PRODUCT BULLETIN
2007-02

.050/(1.27mm) Pitch Single Row Board to Board Connector

RSDS

Material Change

Example of female 20-position, .050/(1.27mm) single row board to board connector.

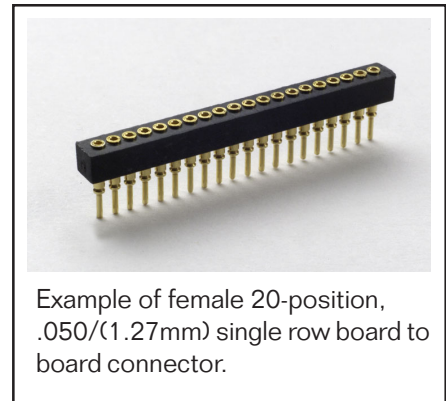
Effective immediately, the insulator material used for our molded female, single row .050/(1.27mm) pitch Board to Board Connectors, will be changed from LCP to FR-4. This change affects body type RSDS (molded LCP). Note: RSDS replaced the older body types SDS (molded PBT) and HSDS (molded PPS). The new FR-4 body type designator is **FSDS**. The new FR-4 female connectors (FSDS series) will be offered with only Gold/Gold (GG) terminal/contact plating.
